Conceptual Review Agenda

Schedule for 04/04/16 to 04/04/16

Monday, April 4, 2016

1519 Cedarwood Dr Single-family Detached

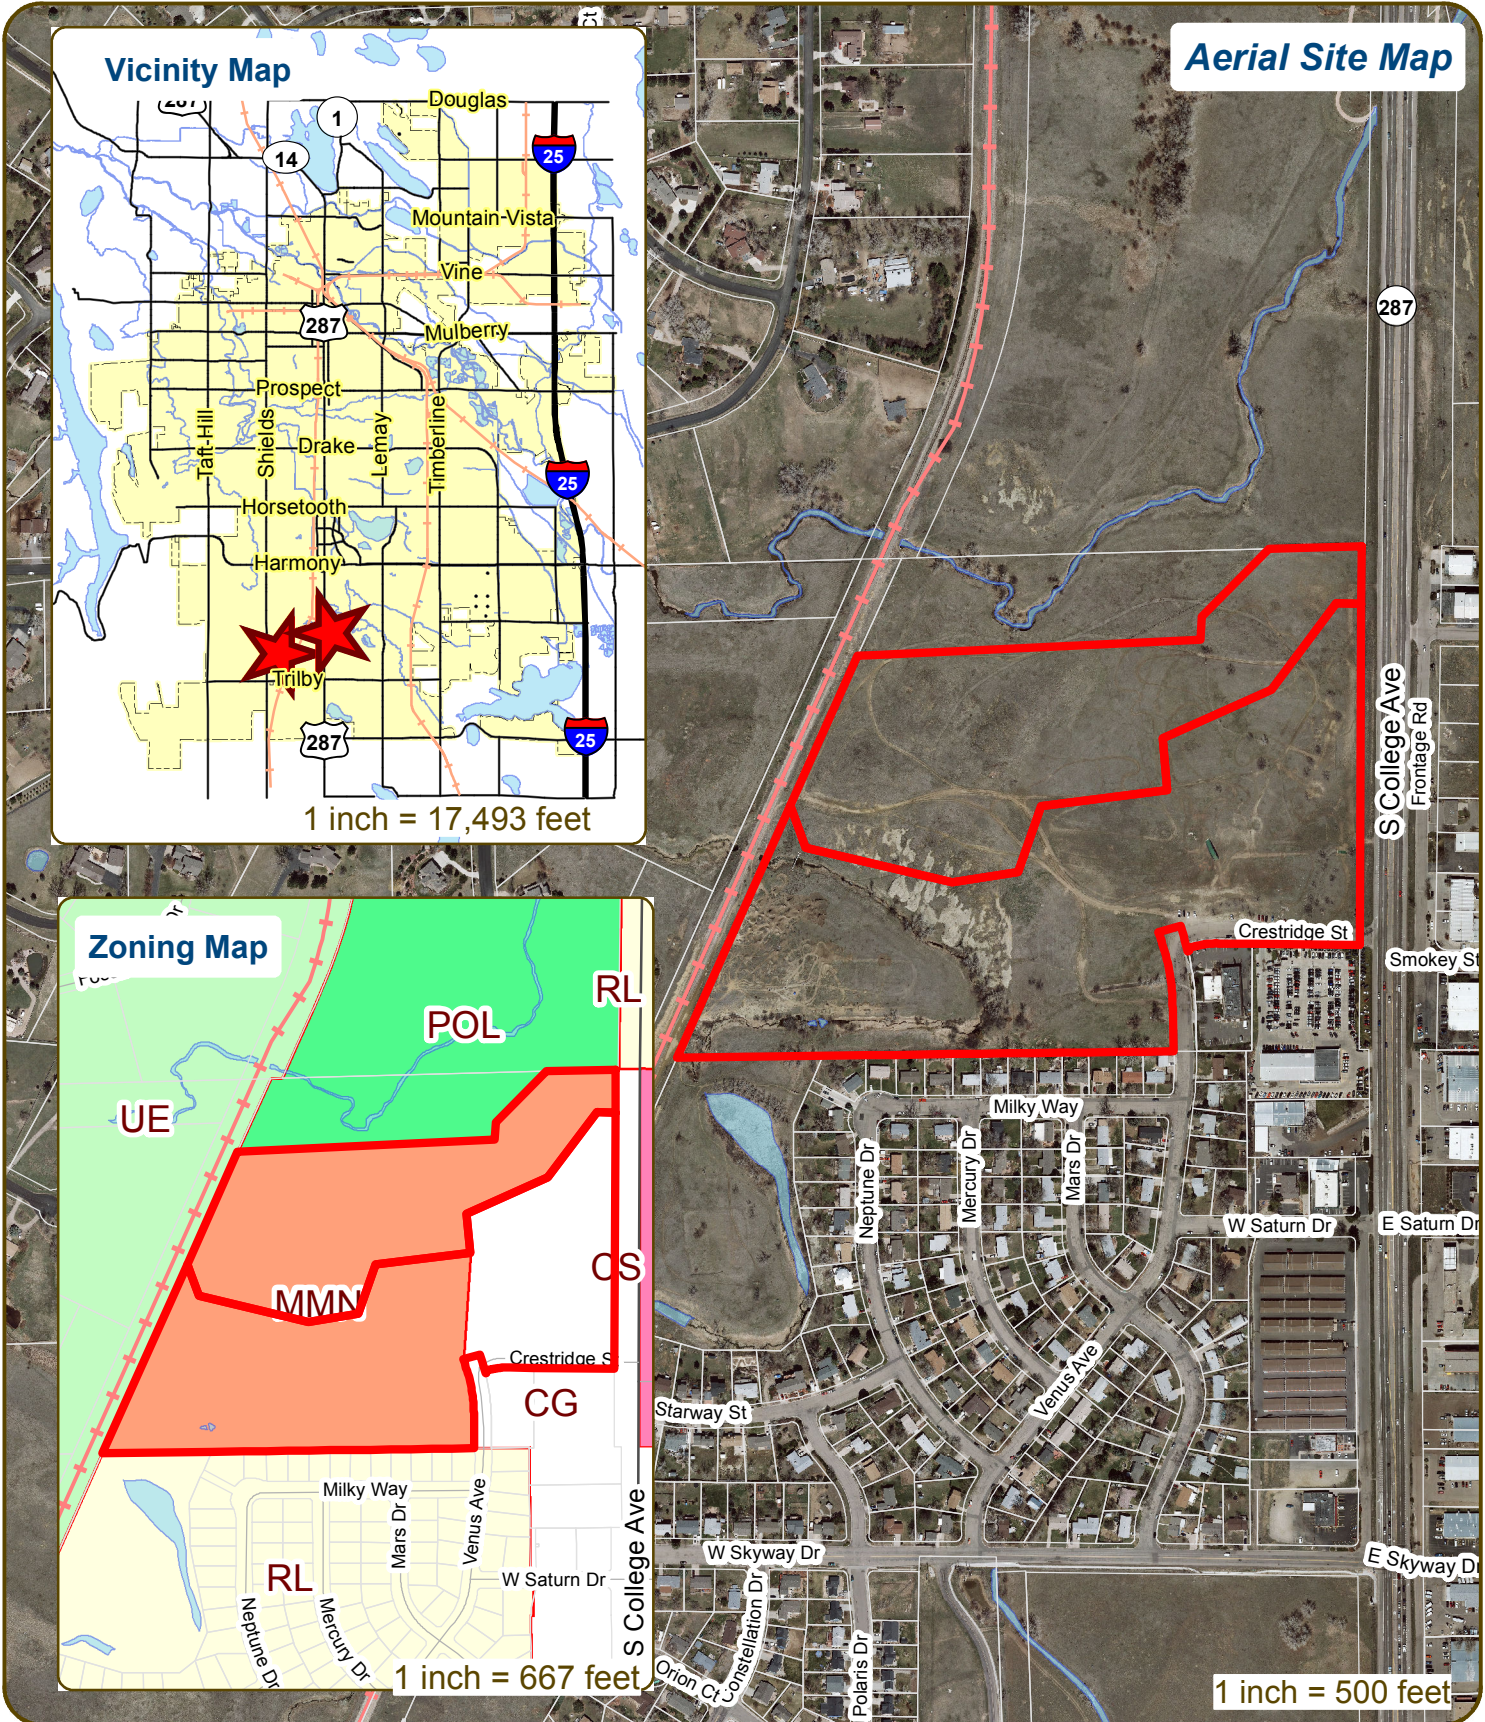
1. The property is currently 1 lot. To add an additional primary structure the property will need to be replatted into 2 lots.
2. In the Low Density Residential (R-L) zone district the minimum lot is is 6,000 sf.

The floor area of each lot cannot exceed 1/3 of the Lot size.

4. The maximum building height is 28ft.
5. Single family detached dwelling is subject to a Type 1 review. The submittal will need to include a plat and site/landscape plan.

DES.	CHK.	DATE	DESCRIPTION
SS	MC	03.08.16	CONCEPT REVIEW LOT PLAN

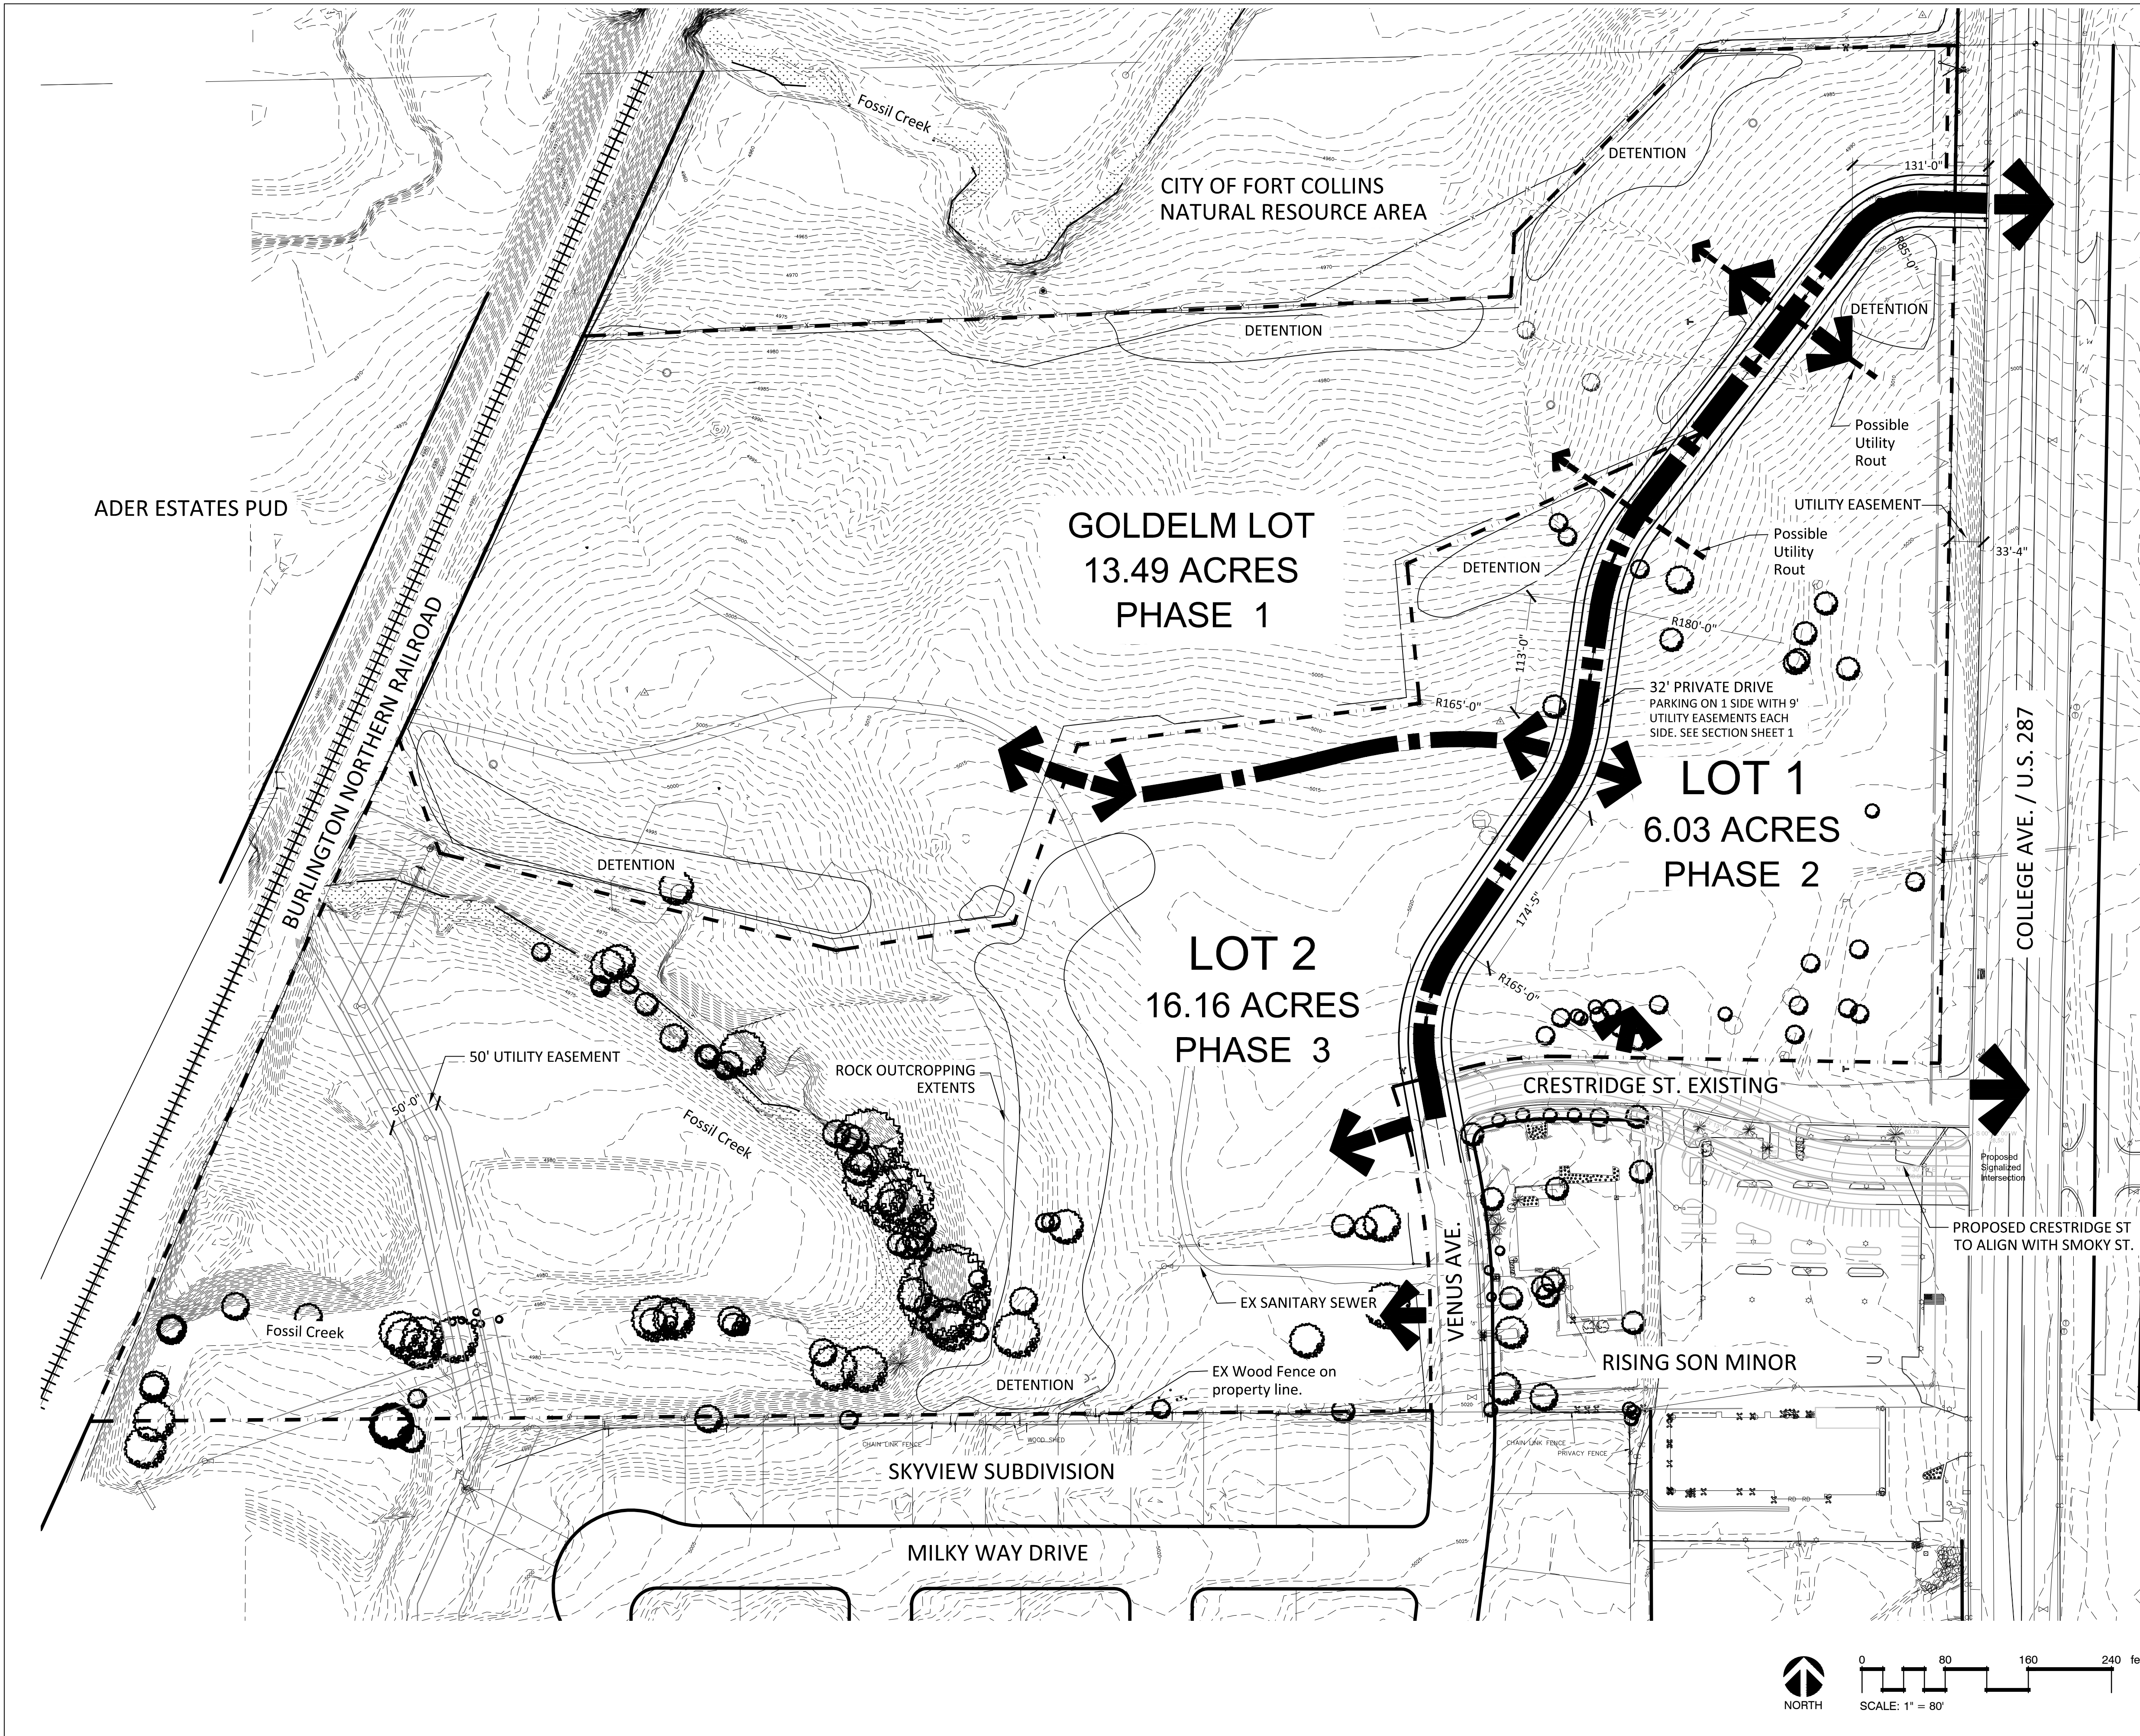
5. Please show Pedestrian/Bicycle routes and access points.
6. Is there plans for open space or parks? Plan shows 1,554,220 sq. ft. of total space with 620,500 sq. ft. of that being impervious.
7. Street trees are required to be installed along all abutting right-of-way.
8. The use of the property of uses not approved prior to Development Review is prohibited. (Vehicle storage)

10. Venus Drive or an adequate access needs to be extended north thru this site to serve the parcel to the north. Adequate design and dedication of row/easement shall be provided. The plan that was submitted shows a private drive making this connection, which looks like it will work for this. The connection from Venus to the site to the north does not need to be a street, it can be a drive provided it is designed adequately (width, features, sidewalk connection and grades) to meet Transportation and Poudre Fire Authority needs.

- 15.** Per the access control plan the intersection of SH287/ Crestridge Road/ Smokey Street could be signalized if the streets (Crestridge and Smokey) could be aligned, the intersection meets traffic signal warrants and the grade of the intersection approaches are reduced. If the intersection cannot be aligned then the plan shows that this access shall become a right-in right-out intersection. The conversion of the intersection to a right-in right-out configuration will probably be triggered by the additional traffic that would be added to this intersection by this development. This intersection currently has a high accident rate due to the offset in the roads and limited visibility due to not quite being at the crest of the hill. The plan submitted does not show the realignment of Crestridge.

1. Show the boundary / limits of the ODP and this would need to include the existing and proposed limits of the Crestridge right of way, which would need to be a part of the ODP in tandem with the traffic study.

2. Coordinate with Goldelm and show all spur trail connections and proposed routes including the approximate location of the main City trail through the Redtail natural area. Show a distinct linetype and label the public trail connections.

3. Re-alignment of Crestridge, show the existing and proposed ROW. Label which phase will include the construction of this area with and which phase will include the traffic signal.
